H11691

DESCRIPTIVE REPORT

Project OPR-O190-RA-07
West of Prince of Whales Island
Vicinity of Maurelle Islands, Alaska
Scale 1:10,000
May-July 2007
NOAA Ship RAINIER (s221)
Chief of Party: Commander Guy T. Noll, NOAA

Revisions Compiled During Office Processing and Certification

Figure 7: Showing two areas that the hydrographer recommends be superseded by a combination of singlebeam and C3D bathymetry (Chart 17404).

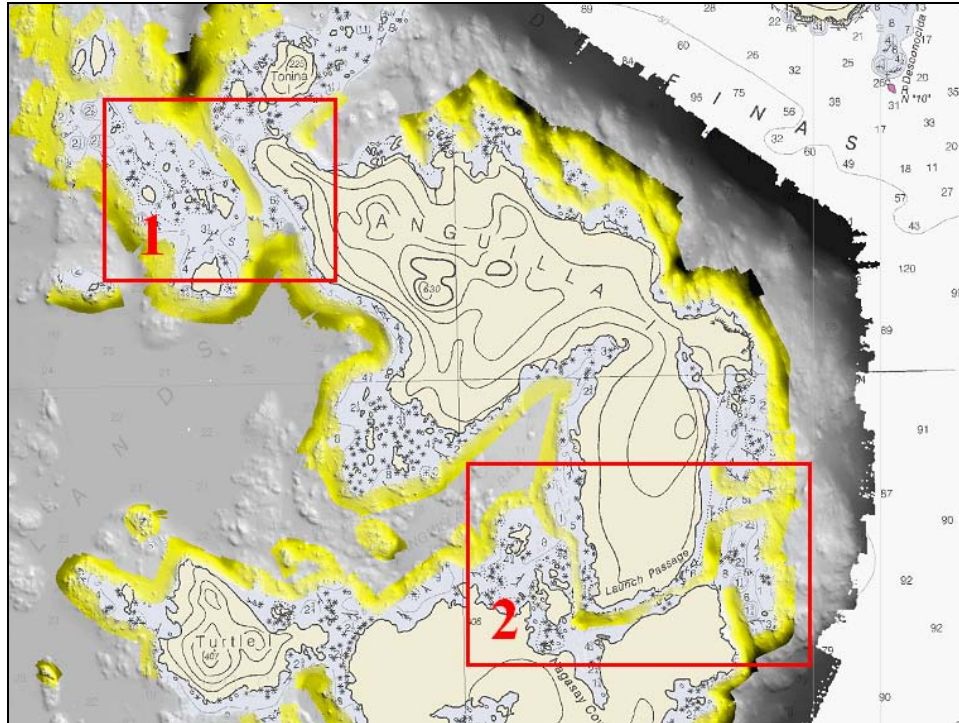
There are two locations where the hydrographer recommends that C3D bathymetry be used to supersede charted depths¹⁴. In the two places shown below where bathymetry is from only singlebeam and C3D, the C3D data was substantially cleaned to leave a strip of data that remained wider than the singlebeam data. In these areas, the hydrographer recommends superseding previous charted depths with C3D bathymetry in addition to the singlebeam data.

In Figure 7 above, the red box labeled '1' features a narrow passage west of Anguilla Island that has only singlebeam and C3D data. The red box labeled '2' features an area known as 'Launch Passage,' a narrow channel leading from the Gulf of Esquibel to the center of the Maurelle Islands. This was also only covered with singlebeam and C3D. The hydrographer recommends that these areas be superseded by a combination of singlebeam and C3D bathymetry. A closer examination of each of these areas is shown below in Figures 8 and 9.

¹⁴ Do not concur. As the system is still in an experimental status and its bathymetry has not been shown to meet NOAA standards, C3D depth data included with the survey records is for evaluation purposes only and was not used to create office generated BASE surfaces.
